Service Bulletin

Subject: Rub Type Noise Heard with Steering at Full Turn (Steering Stop) While Driving (Vehicles Equipped with Optional Dealer Installed 19" Wheels Only)

Models: 2013 Cadillac ATS with Dealer Installed 19" Wheel/Tire Package

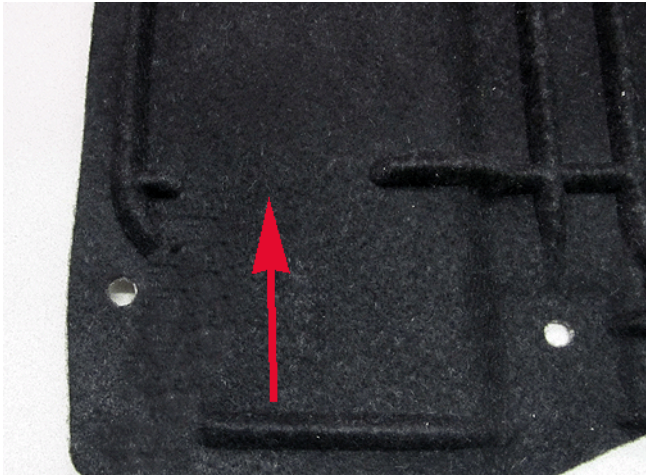
Some customers may comment that after the installation of the 19" accessory wheel and tire package, there is a rubbing noise heard at full turn (steering stop) while driving.

This condition may be caused by the tire contacting a raised section of the front wheelhouse splash shield.

- **Updated design (Rib Removed)**

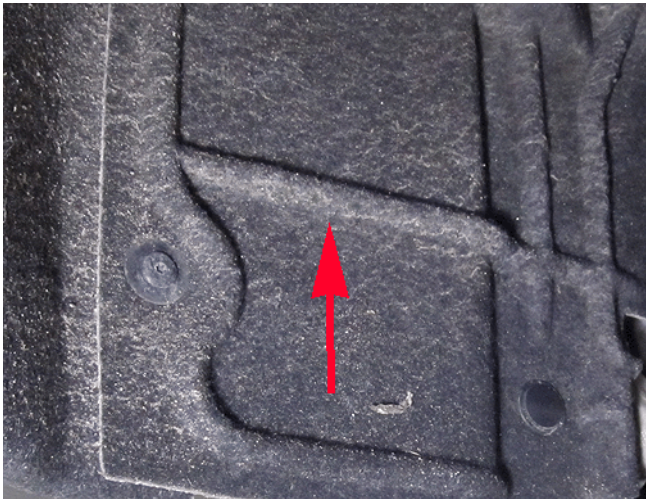
1. Determine if the vehicle is equipped with the updated design wheelhouse shield.

- **Original Design (Full Length Rib)**

- If the vehicle is equipped with the original design (full length rib), order both the left and right service parts with the updated design. The following step are performed on the updated part.

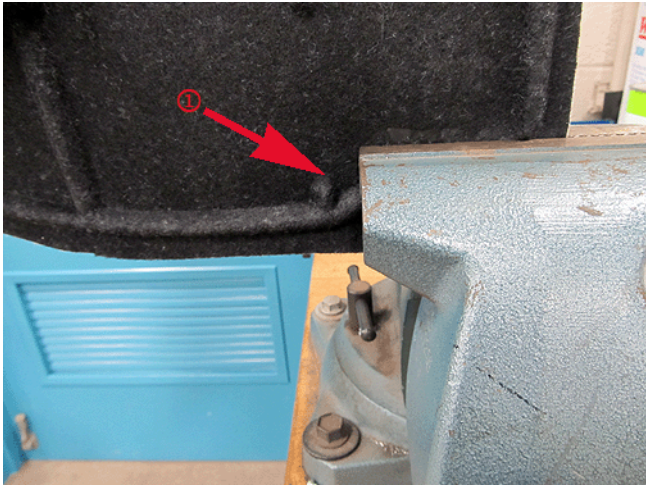
3. Heat the wheelhouse splash shield in a localized area to soften the part for approximately 1 minute (holding 1-2 inches above the part).

4. Using a bench vise, insert the splash shield as shown and close the jaws on the vise. Do not go past the rib (1) when inserting the splash shield into the vise. Allow the part to cool in the vise for a few minutes.

Ensure the ridge is flattened as shown. If not, repeat the above steps.
